Process Change Notification PCN18-2014

Installation of improved fab metallization process for 0.35 μ m technologies

Metallization and interconnect – schematic

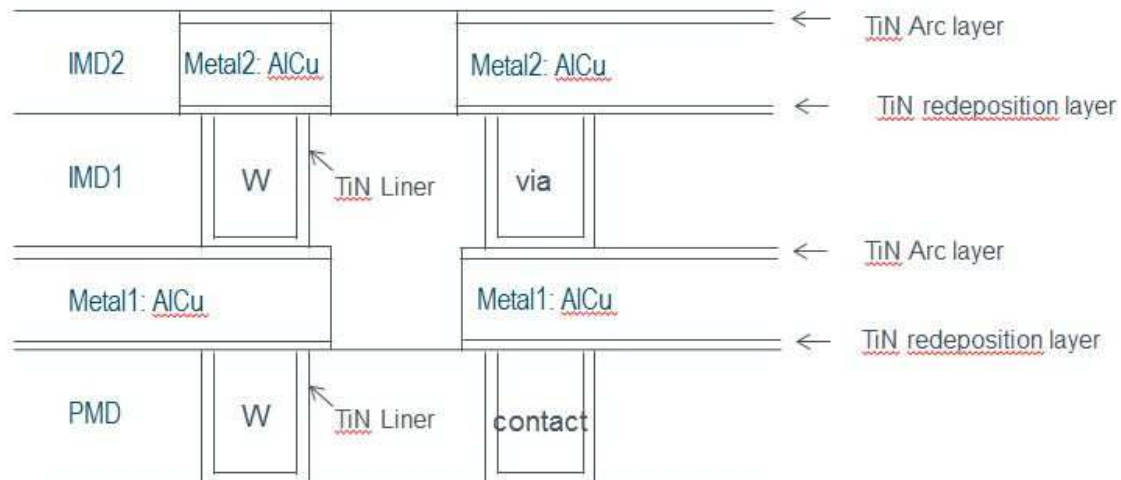
OLD PROCESS		NEW PROCESS	
contact	Contact/via formation	contact	Contact/via formation
liner	Liner deposition	liner	Liner deposition
WxD	Tungsten deposition	WxD	Tungsten deposition
	Tungsten etch back	CMP	Tungsten CMP
		Ti/TiN	Ti / TiN Redeposition
MxD	Metal deposition Arc layer	MxD	Metal deposition Arc layer

Old process:

New process:

X-Section: STEM

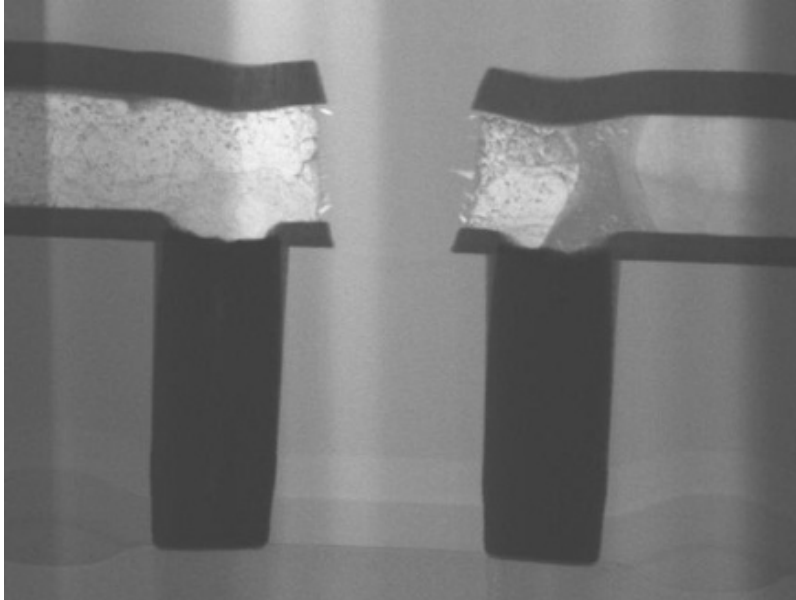
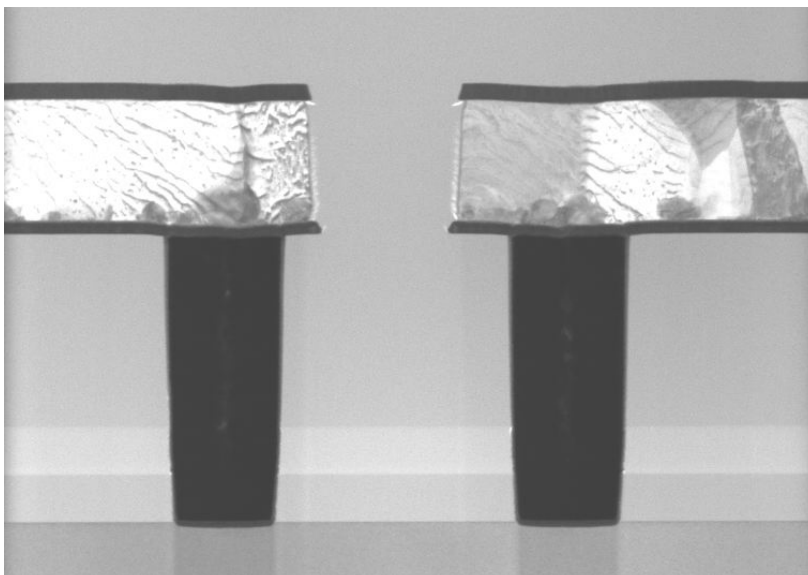
Old Process:

New process:
